TECHNICAL SERVICE BULLETIN

REF.: AUDIO
NO.: AU91-007
DATE: DECEMBER 27, 1991
MODEL: ALL MODELS

1992 RADIO "TAPE" & "CD" BUTTON ILLUMINATION LOGIC CHANGE

ILLUMINATED AREA

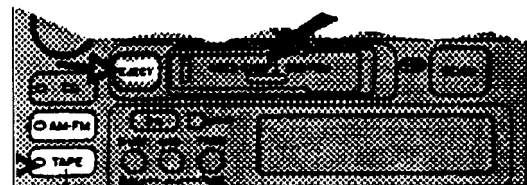
The "TAPE" and/or "CD" buttons on '92 radios are designed so they will illuminate only when these modes of operation are functioning (parking/headlights "ON").

If a Cassette or CD is not inserted and the Parking/Headlights are "ON," the "TAPE" or "CD" buttons do not illuminate. However, the Cassette or CD door, and AM/FM button are illuminated.

CD ILLUMINATED

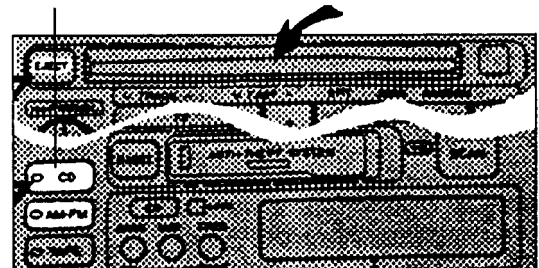
When a cassette is inserted with the Parking/Headlights "ON," the cassette door light goes out and the "TAPE" button illuminates.

When a CD disc is inserted with the Parking/Headlights "ON," the CD door goes out and the "CD" button illuminates.
